ATTACHMENT A

EXISTING TECHNICAL SPECIFICATIONS AND BASES
UNIT 2

ATTACHMENT B

PROPOSED TECHNICAL SPECIFICATIONS AND BASES
UNIT 2

FIGURE 3.4-7

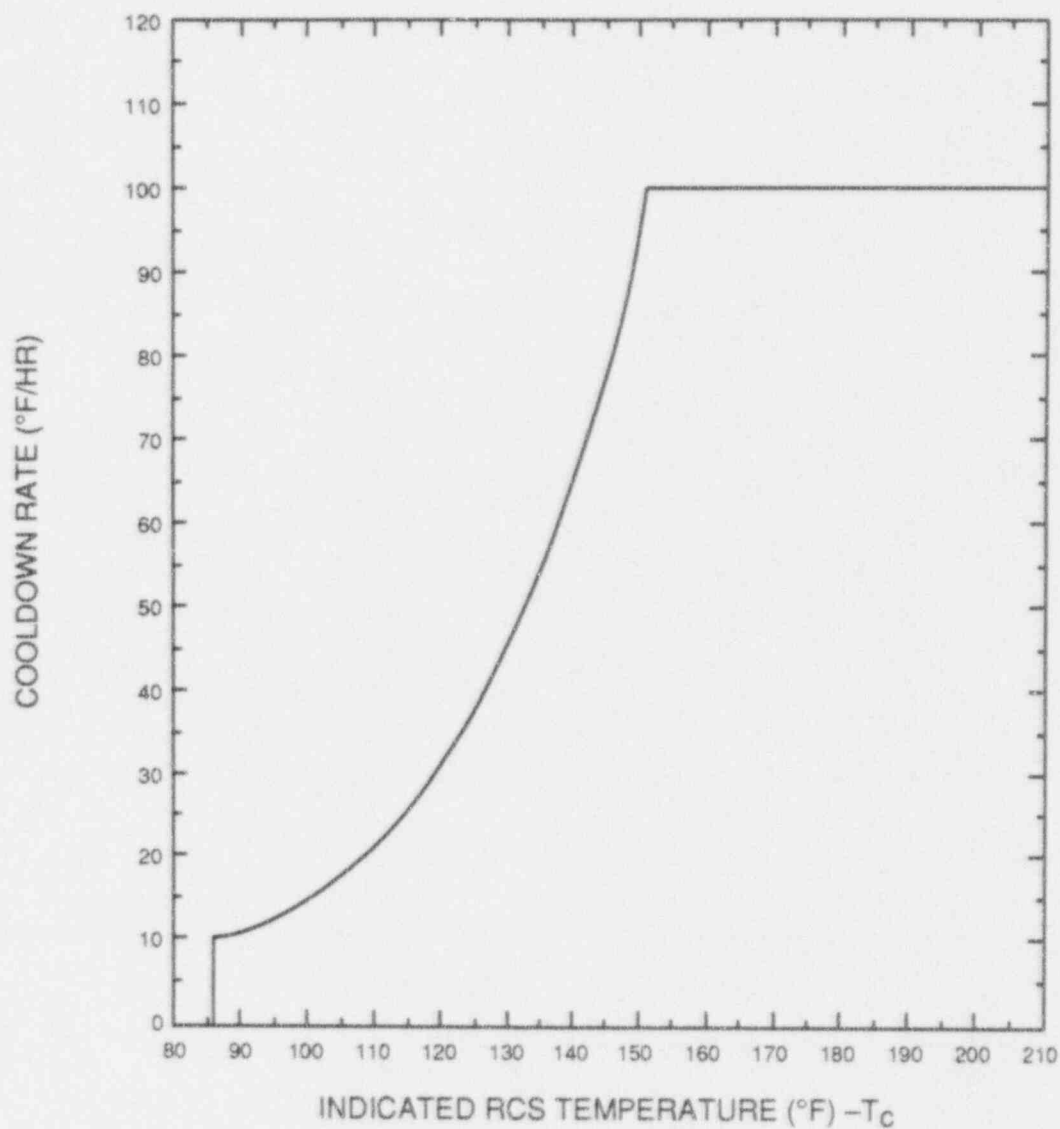
NOTE: A MAXIMUM COOLDOWN RATE OF 100°F/HR IS ALLOWED
AT ANY TEMPERATURE ABOVE 151°F

SONGS 2 RCS PRESSURE/TEMPERATURE LIMITS
MAXIMUM ALLOWABLE COOLDOWN RATES (UNTIL 8 EFPY)
Remote Shutdown Operation
